**Comments on Docket No. FHWA-2020-0001 National Standards for Traffic Control Devices;
the *Manual on Uniform Traffic Control Devices for Streets and Highways*; Revision**

5B.05	NO	NO	YES	BNSF opposes the inclusion of the second paragraph of the proposed Guidance statement (page 515 at lines 1-2) recommending that V2I communication should be used to relay train arrival or presence. BNSF also opposes inclusion of the Support statement proposal (page 515 at lines 7-9) indicating CAV needs are better addressed through V2I infrastructure. Active grade crossing equipment has not been designed or equipped for V2I communication, and there is no evidence to support the statement that it could be more reliable or accurate for CAV use. Rather, it is imperative that CAVs be equipped and capable of reliably detecting existing crossing activation devices based on machine vision, to ensure motorists are adequately protected across the broad range of grade crossing scenarios.
8A.01	NO	YES	N/A	<p>After the term “privately-owned roadways” in the first sentence of the Standard in this section (line 33 on page 680), FHWA should add the words “pathways or sidewalks”, because not all private at-grade

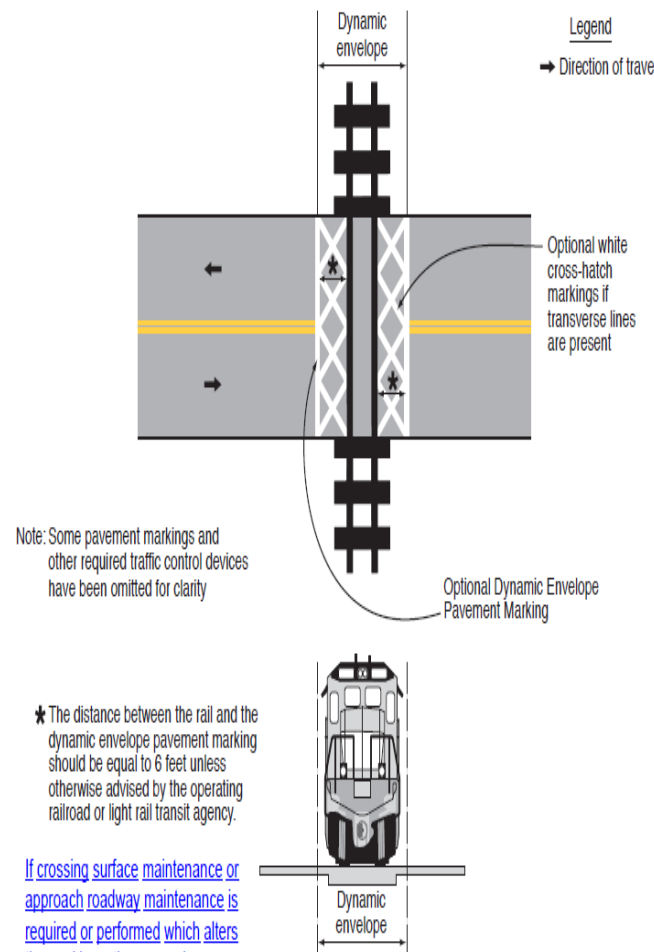
8B.04	NO	YES	N/A	<p>BNSF requests FHWA delete the words “deemed essential by an engineering study” in the Guidance statement on page 692 (line 10) of this section, and instead insert the words “determined by a Diagnostic Team.” FHWA should also revise the following sentence (beginning on line 19 of page 692) to read as follows (proposed additions are reflected by underlined language, with strikeouts reflecting proposed deletions):</p> <p><i>“If the STOP sign is installed at the Crossbuck Assembly instead of at the highway-highway intersection, <u>a Diagnostic Team should consider</u> should be given to installing a YIELD sign or intersection <u>some other traffic control device at the highway-highway intersection.</u>”</i></p> <p>BNSF recommends this revised language because a Diagnostic Team with railroad representation should be involved in determining unusual situations that warrant use of STOP sign at a grade crossing, and to evaluate t-intersections for proper signage.</p> <p>FHWA should also amend the first sentence of the proposed Standard (page 692, lines 24-27) in this section to read as follows:</p> <p><i>“If a Crossbuck Assembly is installed on the approach to a passive grade crossing located at a highway-highway intersection controlled by a traffic control signal that is not interconnected with the grade crossing and not preempted by the approach of rail traffic, <u>a Diagnostic Team shall be convened to determine the appropriate traffic control devices. YIELD sign with a TO TRAINS (R15-9P) supplemental plaque shall be installed on the Crossbuck Assembly.</u>”</i></p>

This recommendation is made because the “TO TRAINS” supplemental plaque is not necessary, and if included there should be a sign figure. Further, a Diagnostic Team with railroad representation included should be involved in determining the appropriate traffic control devices at a highway-rail grade crossing.
8B.16	NO	YES	N/A	<p>FHWA should delete the sentence in the Standard (beginning on page 698 at line 16) regarding the LOW GROUND CLEARANCE plaque only remaining in place for 3 years. For safety reasons, and so all drivers regardless of familiarity with a crossing are made aware of low ground clearance, BNSF recommends the plaque remain in place permanently (per Part 2).</p> <p>BNSF also requests the proposed Guidance statement on page 698 at lines 18-22 should instead be deemed an “Option”. The word “should” in the proposed language on line 21 of page 698 should be replaced with the word “may”. The phrase “or in place of” (also on line 21) should be deleted. These proposed changes will allow a road authority the flexibility to make the appropriate safety decisions depending on the type of vehicle that needs to be addressed at a particular crossing.</p>

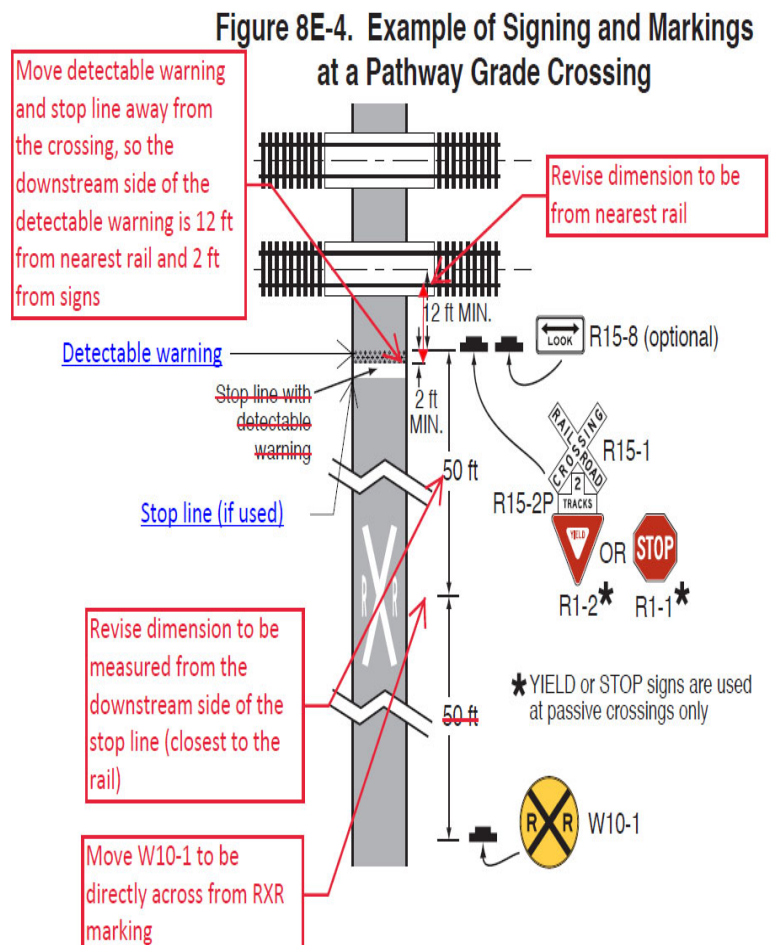
8E.04	NO	YES	N/A	<p>BNSF recommends that the proposed Guidance statement in this section on page 731 (at lines 20-24) be revised to read as follows (proposed additions underlined, strikethrough reflecting proposed deletions):</p> <p>“If used at pathway or sidewalk grade crossings, the stop line should be a transverse line <u>that extends across the full width of the pathway or sidewalk</u> at the point where a pathway or sidewalk user is to stop. <u>If no detectable warning is provided,</u> tThe stop line should be placed at least 2 feet upstream from the automatic gate, counterweight, flashing-light signals, or Crossbuck assembly (if any of these are present), and at least 12 feet <u>perpendicular</u> from the nearest rail.</p> <p>BNSF recommends this amendment so the Guidance statement is consistent with the detectable warning standards and to clarify that the dimensions cited are only applicable if detectable warning is not provided.</p> <p>Next, in a following Guidance statement in this section on page 732 at lines 4-12, BNSF recommends that the discussion be revised to read as follows (proposed additions underlined, strikethrough for proposed deletions):</p> <p>“The width <u>upstream to downstream dimension</u> of the detectable warning should be at least 2 feet.</p> <p>Detectable warnings should be placed immediately downstream from the pathway or sidewalk stop line <u>approaching the grade crossing</u> (if a stop line is present) or should be incorporated into and made a part of the stop line. The downstream edge of the</p>

detectable warning adjacent to the grade crossing should be located at least 2 feet upstream from the automatic gate, counterweight, flashing-light signals, or Crossbuck assembly (if any of these are present), and at least ~~no less than~~ 12 feet perpendicular from the center of the nearest track nearest rail (see Figures 8E-4).

If the distance between the ~~centers of two adjacent tracks~~ at a sidewalk or pathway grade crossing is ~~more than 38 feet~~ 30 feet or more measured from the inside rail to the inside rail, additional detectable warnings should be used to designate the limits of the pedestrian refuge area (see Figure 8E-5)."

Next, this section references Figure 8E-4. BNSF requests FHWA adopt the below amendments to this figure (additions reflected in red text/strikethrough and blue underlined additional language). These amendments are intended so Figure 8E-4 is consistent with the proposed text of Section 8E.04 as proposed in this comment, and to show the dimensions from the nearest rail and the sign placement consistent with Section 8C.02:

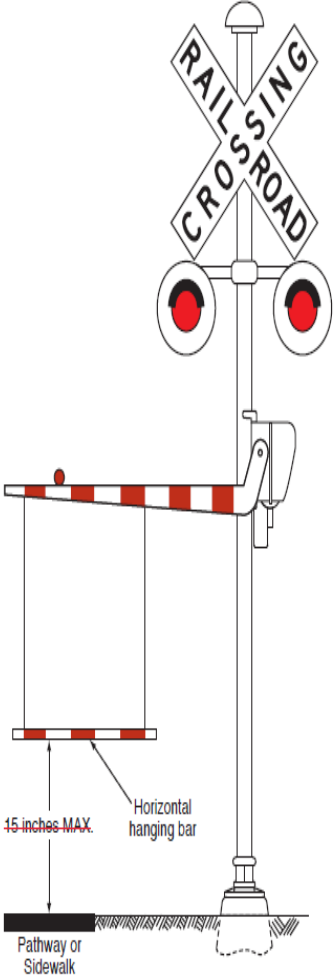
<p>Figure 8E-11. Example of Placement of Automatic Pedestrian Gates at a Sidewalk Grade Crossing</p> <p>A - Sidewalks on Outside of Vehicular Gates B - Sidewalks on Inside of Vehicular Gates</p> <p>Stop line with detectable warning Stop line (if used) Detectable warning Emergency exit route with emergency exit swing gate Fence or pedestrian barriers (connect to existing right-of-way fence, if present) Edge lines may be used to designate emergency exit route</p> <p>Add detectable warning across emergency exit route (all locations in figure)</p> <p>Adjust location of detectable warning and stop line so that there is 2 ft between gate and detectable warning (all locations in figure)</p> <p>BNSF requests FHWA amend Figure 8E-14 to to reflect our comment on the Guidance statement addressing horizontal bar height in this section (as discussed directly above for page 737 on lines 43-45). BNSF's proposed amendments to Figure 8E-14 are reflected in red strikethrough in the figure below:</p>

Figure 8E-11	NO	YES	N/A	See the proposed amendments to Figure 8E-11 in the discussion of Section 8E.09 directly above.
Figure 8E-14	NO	YES	N/A	See the proposed amendments to Figure 8E-14 in the discussion of Section 8E.09 directly above.
